**SUQUEHANNA STEAM ELECTRIC STATION  
SUPPLEMENTAL RESPONSE TO REQUEST FOR  
ADDITIONAL INFORMATION REGARDING  
GENERIC LETTER 96-06 DATED JULY 26, 2001  
PLA-5400**

**Docket Nos. 50-387  
and 50-388**

**SUQUEHANNA STEAM ELECTRIC STATION  
RESPONSE TO REQUEST FOR ADDITIONAL  
INFORMATION REGARDING SUPPLEMENTAL  
RESPONSE TO GENERIC LETTER 96-06  
DATED JULY 26, 2001  
PLA- 5352**

**Figure 1 Drywell Temperature Profiles for Small Break LOCA Accident (SBA) and Loss of Drywell Cooling (LODWC).**

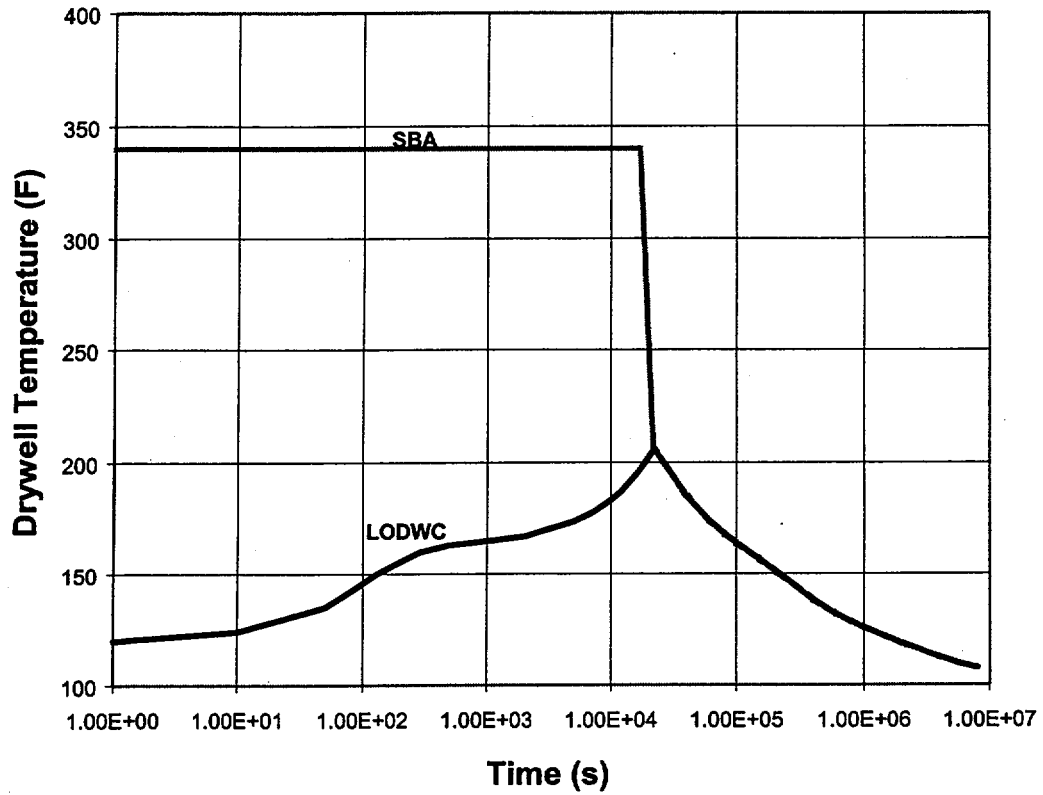
Provide further justification for P[3] - containment heating causes heating and expansion of the water trapped between the isolation valves over-pressurizing the pipe until rupture. At a minimum, please, address additional failure modes such as station blackout and human reliability.

Figure 1 shows the temperature profile associated with the small break LOCA. This temperature profile bounds all other temperature profiles including large break LOCA and Loss of Drywell Cooling. The Loss of Drywell Cooling event provides the bounding temperature for all non-LOCA MSIV closure events such as Station Blackout. The analysis results described in the responses to questions 7 and 8 show that no penetration experiences an increase in internal pressure sufficient to cause a pipe failure for the bounding small break LOCA temperature profile.

The only operator action assumed in the analysis is the initiation of shutdown cooling six hours after the small break LOCA. Emergency operating procedures direct the operators to initiate shutdown cooling. It is expected that the 98 psig interlock will clear in 3-4 hours after the event occurs. Thus the 6-hour assumption bounds the expected time for initiation of shutdown cooling. Operation of shutdown cooling prior to 6 hours will shorten the time in which the drywell is at the peak temperature shown in Figure 1.
